Re: Layla Oaks Subdivision

POADP # 545

P.O.A.D.P REVIEW

Re: Layla Oaks Subdivision - Traffic Impact Analysis (TIA)

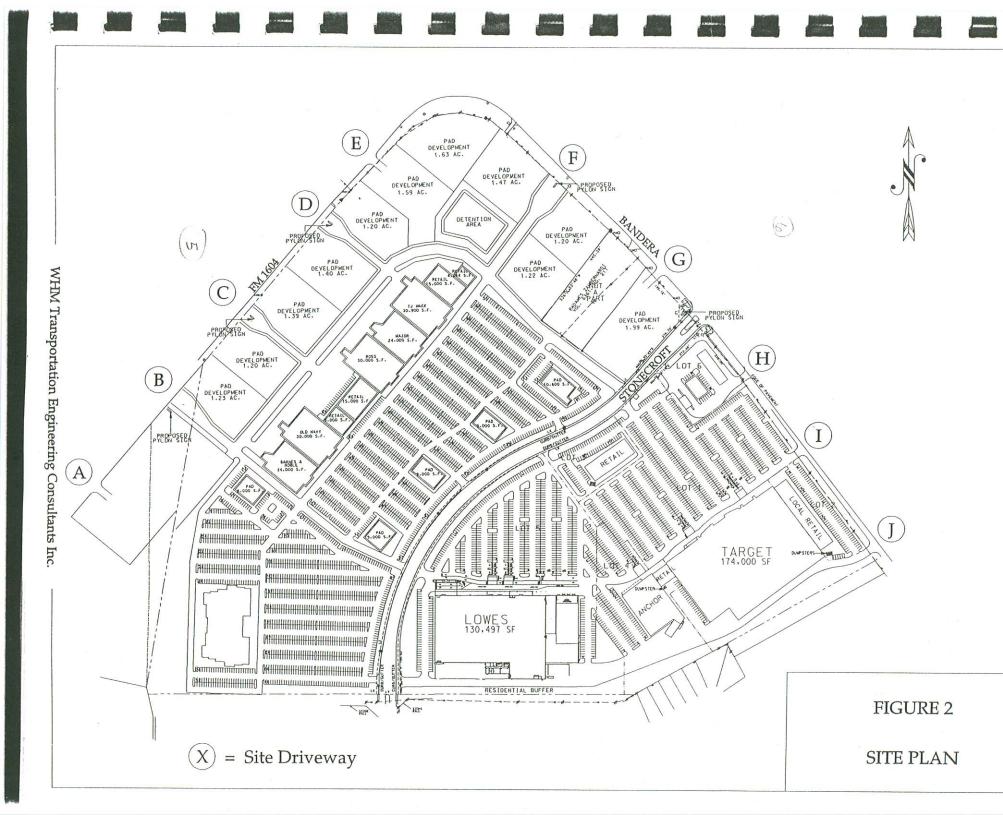
We recently received the referenced document and wish to offer concurrence with the overall access concept as indicated on "Figure 2 – Site Plan" of the TIA report (copy of figure and report cover attached). When the Texas Department of Transportation (TxDOT) received the plat for the subject site, comments were forwarded to the City to the effect that six (6) access points would be allowed along the SH16 frontage and five (5) access points would be allowed along the LP1604 frontage. These maximum numbers of access points have been honored as indicated on the attached drawing, labeled access points A through J. Please note that Stonecroft Blvd. from SH16 into the site is considered to be the 6th access point along SH16.
